ULNRC-04393

**DOCKET NUMBER 50-483  
UNION ELECTRIC COMPANY  
CALLAWAY PLANT  
"RESPONSE TO NRC REVIEWER TELECON QUESTIONS  
REGARDING INSTALLATION OF AUTOMATIC LOAD TAP  
CHANGING TRANSFORMERS TO PROVIDE OFFSITE POWER  
TO THE SAFETY RELATED ELECTRICAL BUSSES"**

Enclosure: XNB02 LTC Transformer Nameplate Drawing (Typical for XNB01)

Waukesha Electric Systems  
P.O. BOX 268 GOLDSBORO, NC 27533  
XNB02  
LTC TRANSFORMER  
NAMEPLATE DRAWING

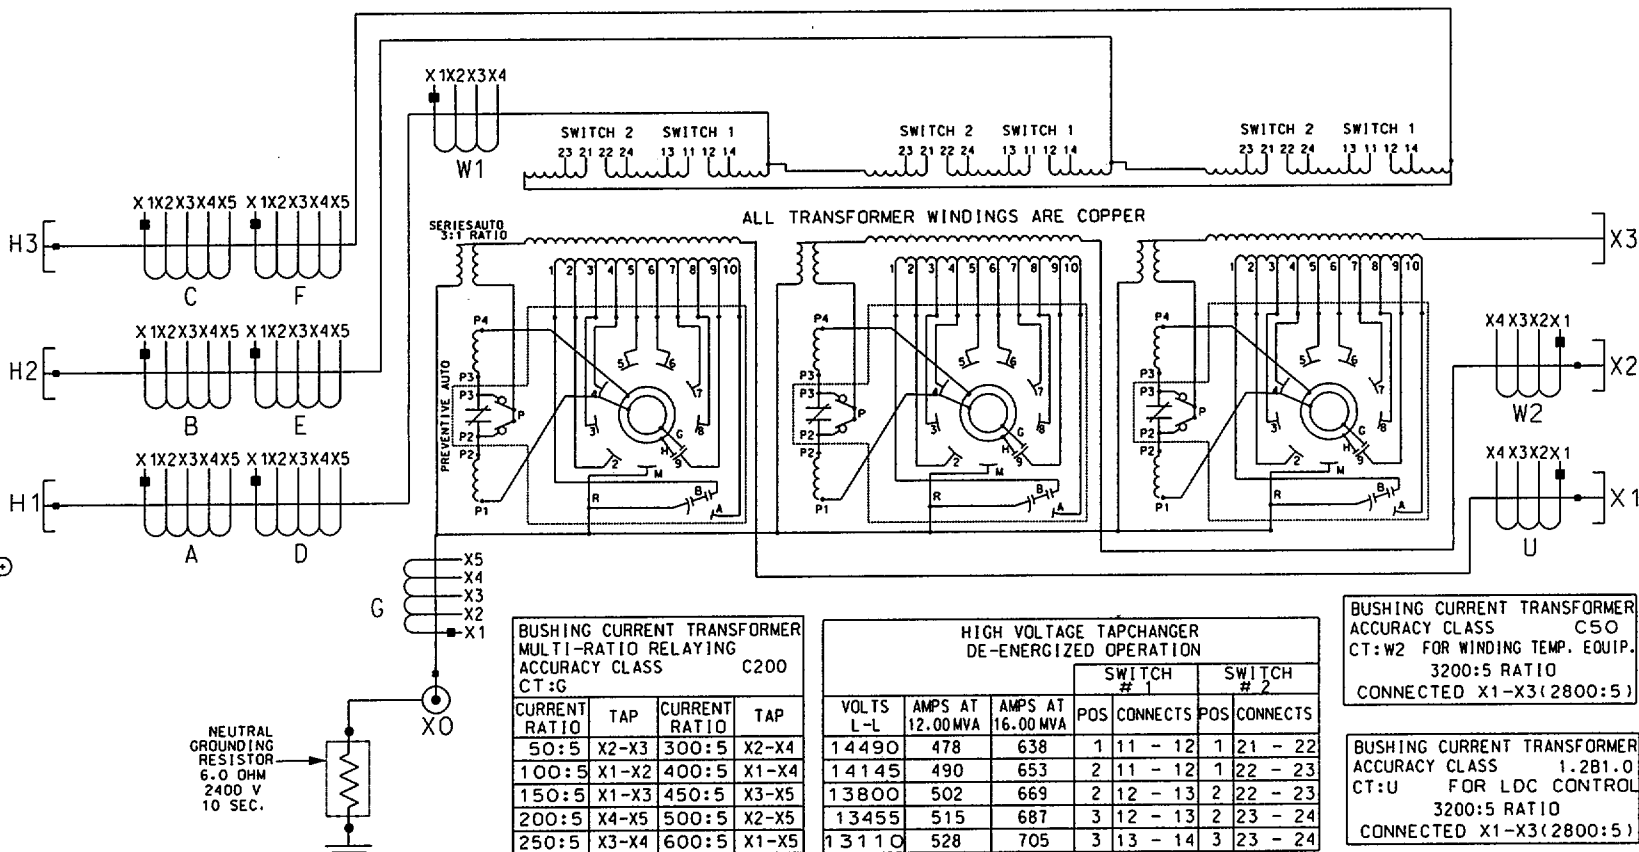
The amendment request states that the new transformers meet the electrical design requirements of the original transformers. [1] Is the auto load tap changer portion of the new transformers capable of handling the same inrush currents while changing taps? [2] Is the tap changing portion of the design more limiting than the transformer portion in terms of load carrying and inrush capability while changing taps?

(1) Yes, the transformer equipment specification required that the transformer with tap changer is capable of switching a current of 4000 amps (at 4.16 kV) at a power factor of 0.5. This corresponds to the locked rotor current of the two largest motors (essential service water pump motors) plus two fully loaded safety divisions and design margin for load growth. Thus this provides for actual plant loading plus a design margin. The manufacturer stated that a series autotransformer is provided with the LTC. The load tap changer and regulated winding would see one third of the secondary load current. A drawing is provided (enclosure) to show the transformer windings and LTC configuration. For a 4000 amp inrush current the LTC would see 1333 amps.

(2) Yes, because the Reinhausen load tap changer is rated for 1500 amps continuous, 3000 amps short time and carries only a portion of the secondary load current.
